**ADDENDUM NO. 1
TO THE
SPECIFICATIONS AND CONTRACT DOCUMENTS**

City Project No. FAC23008O

City Hall Generator

November 24th, 2025

E100

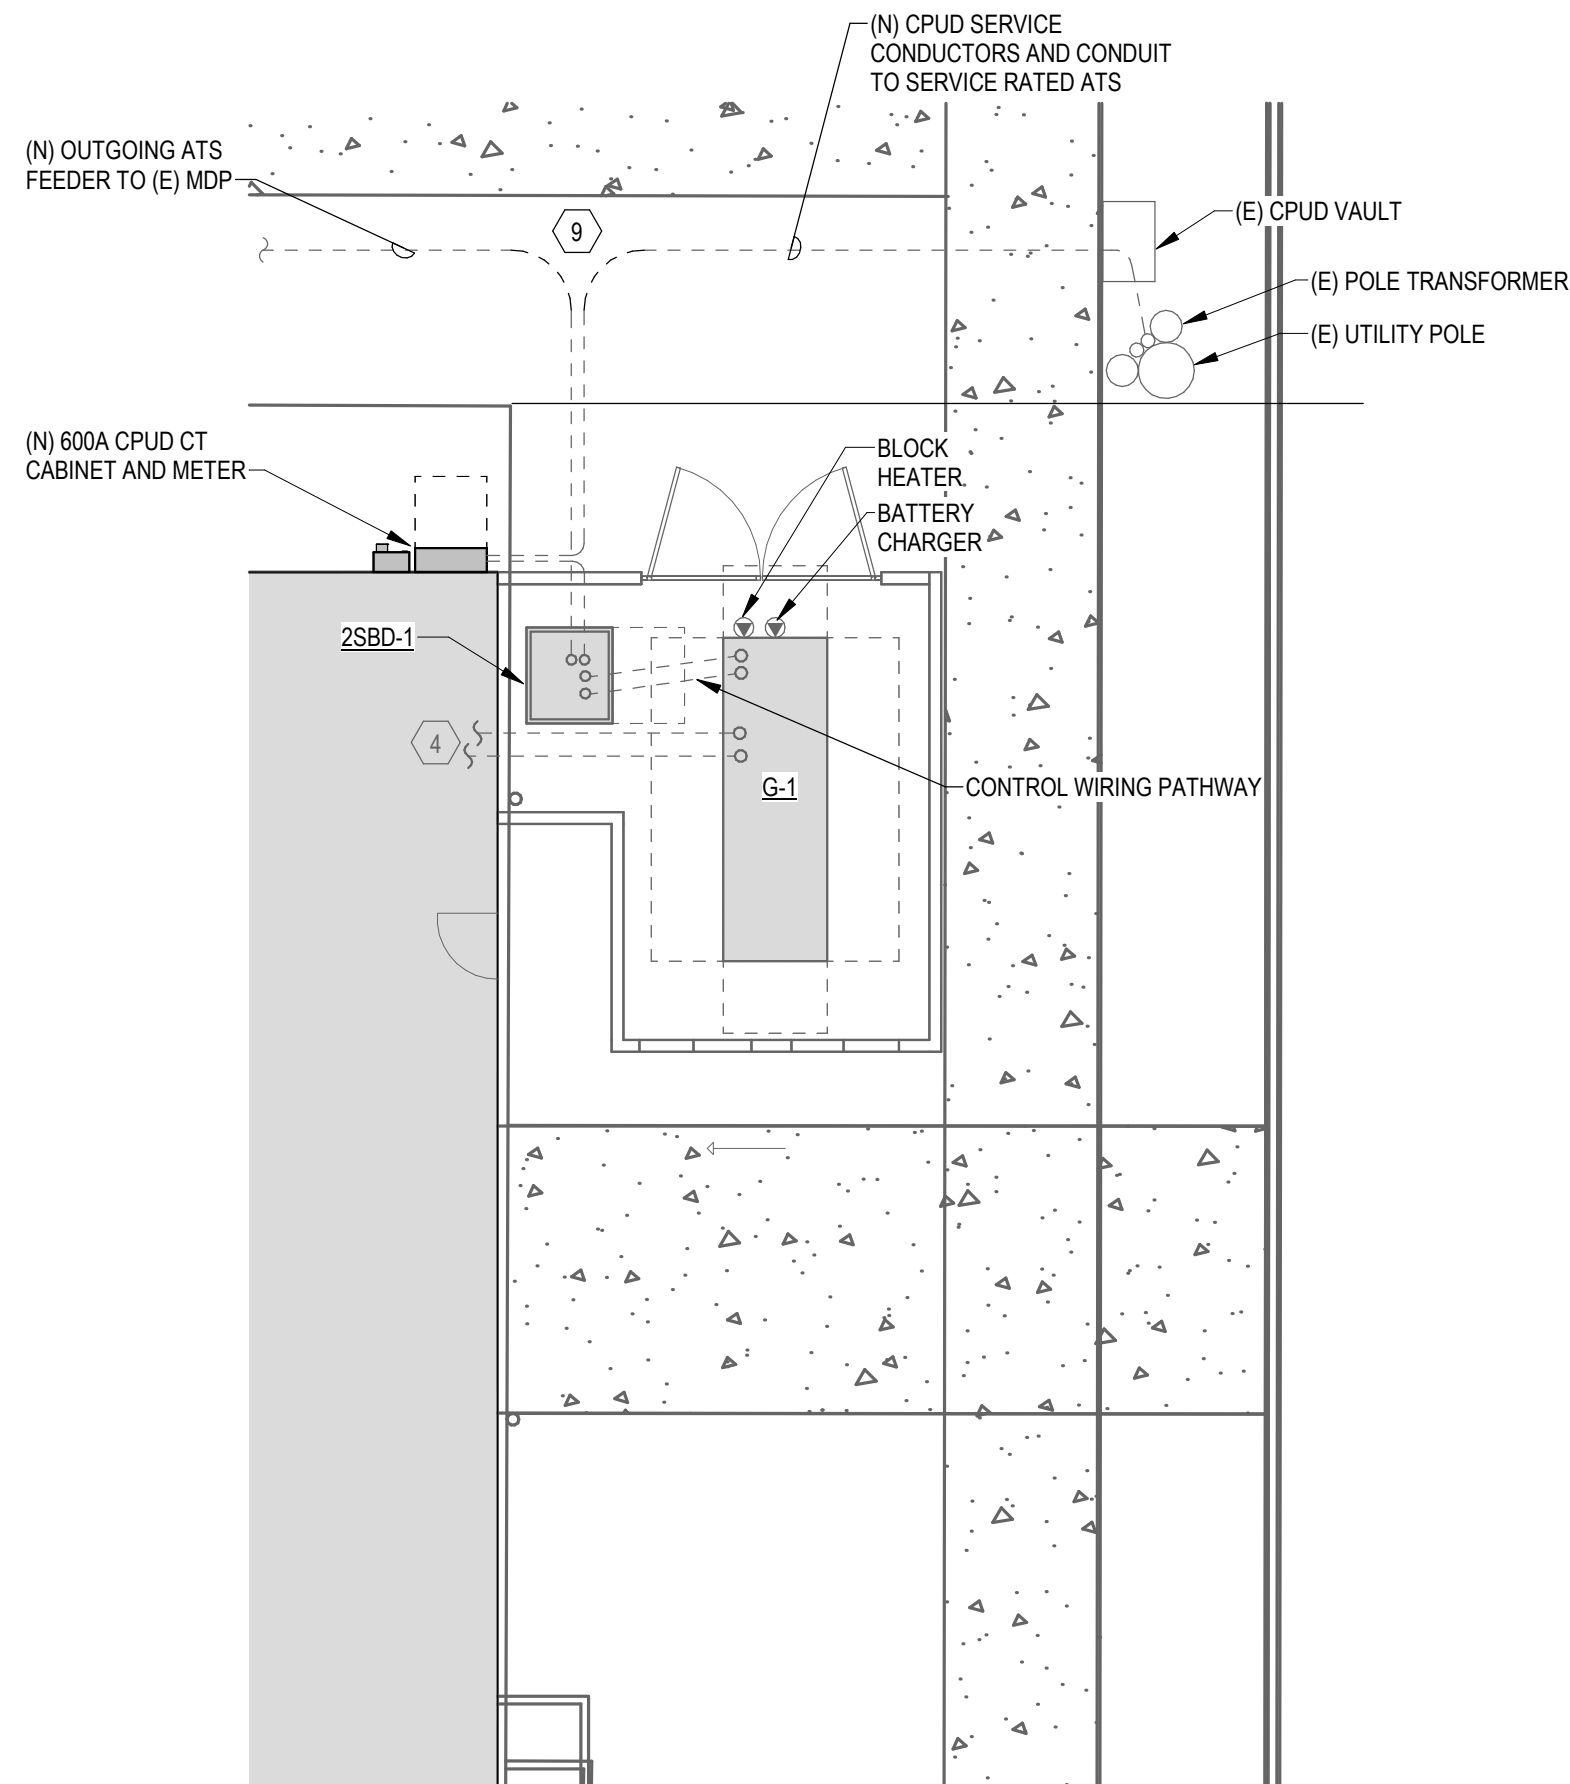
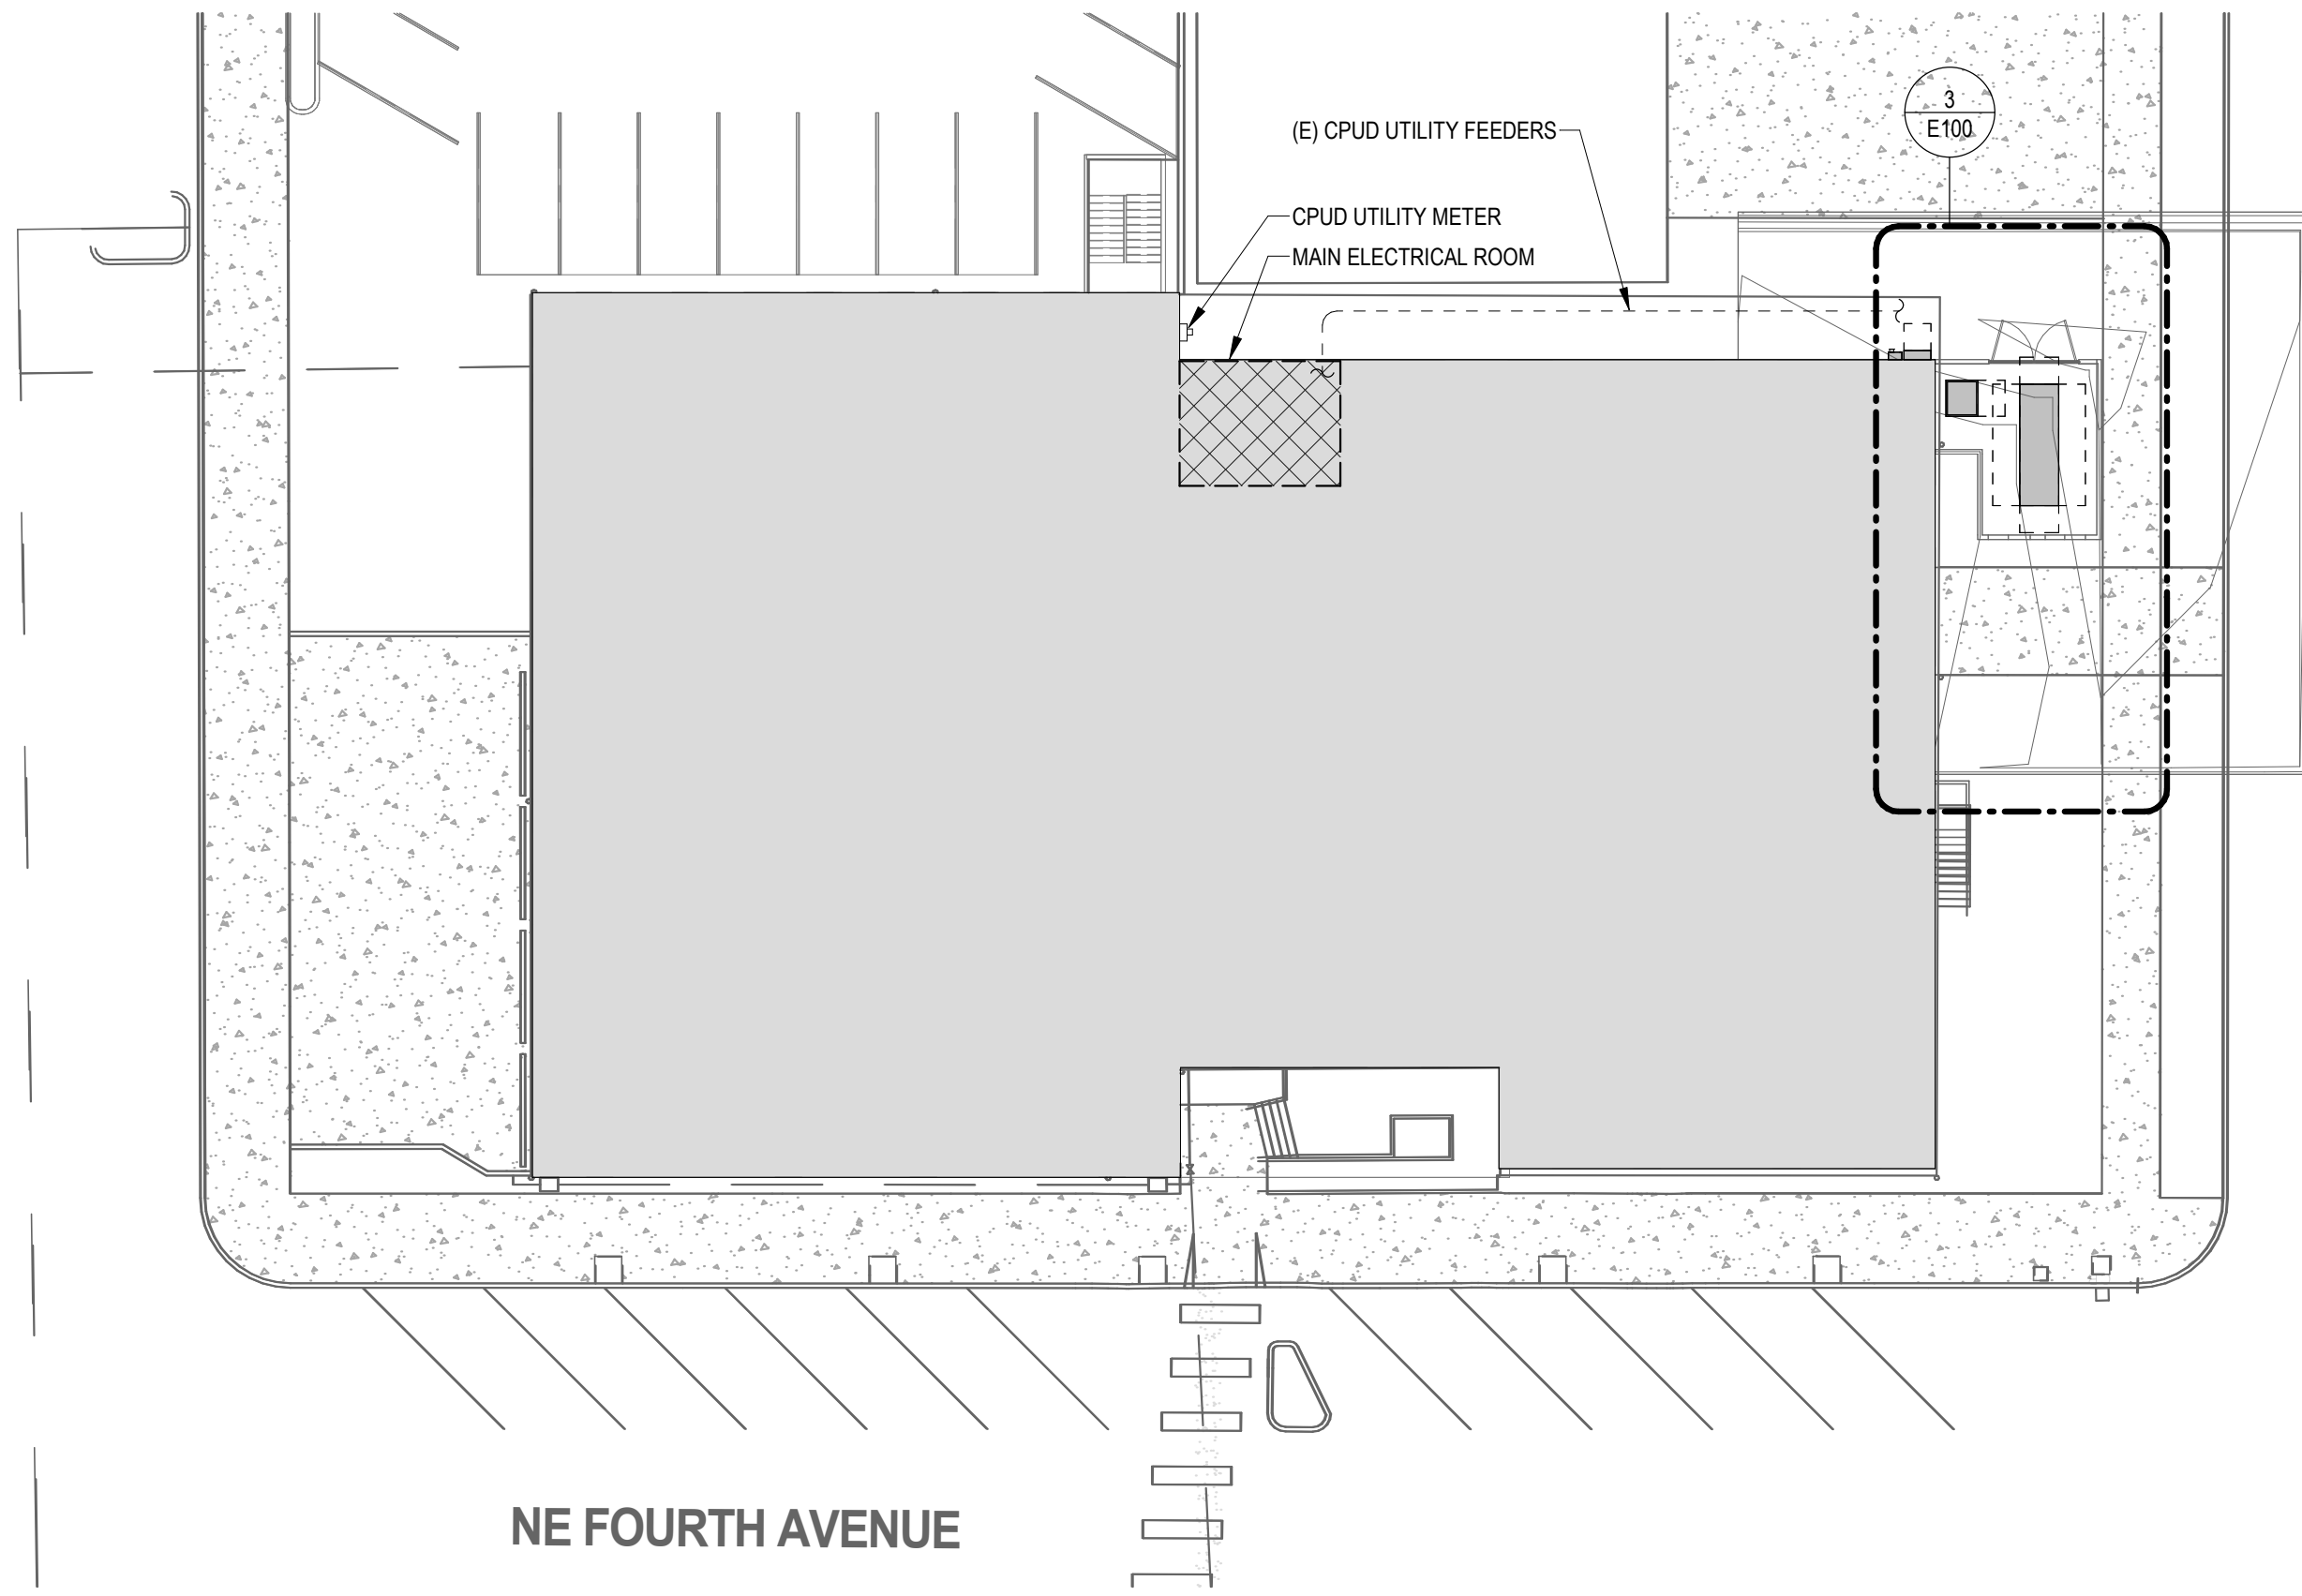
Electrical Scope: The underground utility vault between Clark Public Utilities (CPU) existing power pole and existing CPU meter location has been revised. There will be no Clark Public Utilities involvement on this project. See revised electrical plan sheets.

Electrical Plan Sheets E100 and E601

Delete plan sheet E100 and E601 in their entirety and replace with revised plan sheets.
See attach plan sheet E100 and E60.
